***Development Special Use Permit #2020-10022
Victory Center Retail/Commercial Building –
5001 Eisenhower Avenue***

Purpose of Application
The applicant requests approval of a Development Special Use Permit (with site plan) to allow for the construction of a new retail building with a drive-through facility on the southwestern portion of the property shared with an office building and its associated surface parking.
Applications/Special Use Permits/Modifications Requested:
Development Special Use Permit (with site plan) to construct a new retail building including a Special Use Permit for a drive-through facility.

Staff Recommendation: APPROVAL WITH CONDITIONS
Staff Reviewers: Robert M. Kerns, AICP, Division Chief robert.kerns@alexandriava.gov Maya Contreras, Principal Planner maya.contreras@alexandriava.gov Nathan Randall, Urban Planner nathan.randall@alexandriava.gov

Site Plan Excerpt (Sheet P-1101)

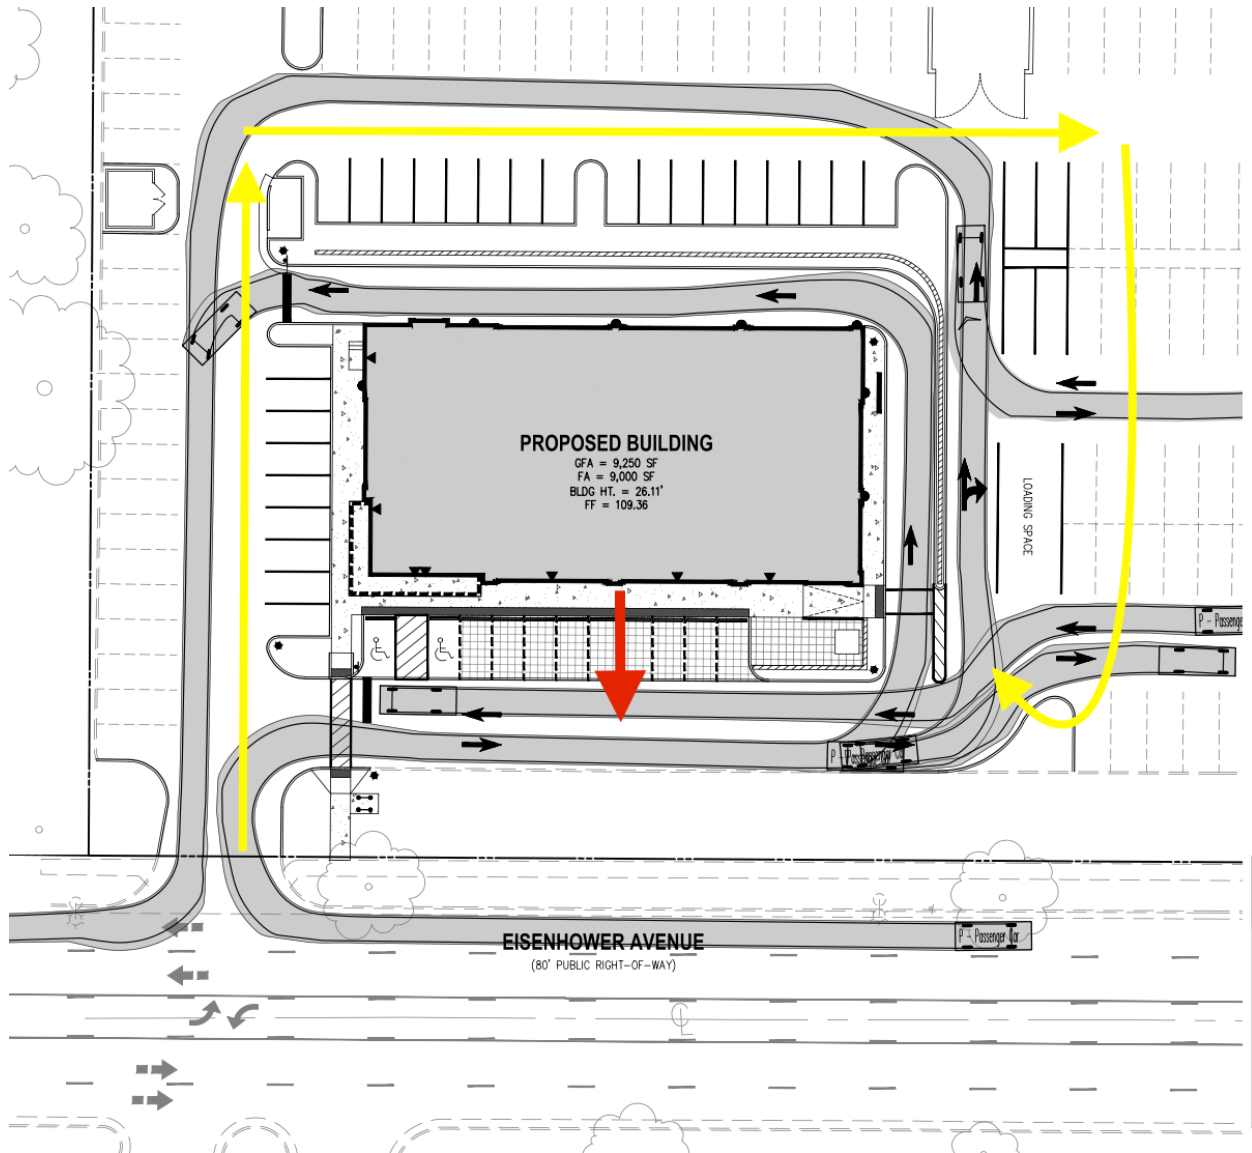
- As designed, use is isolated by driveways and parking from street, sidewalks, and public realm.
- Yellow lines added by me to show rough, indicative possible idea for alternate vehicular circulation that could allow building to front the street and retain drive-through.
- Red line indicates building and outdoor seating area shifted to front sidewalk.
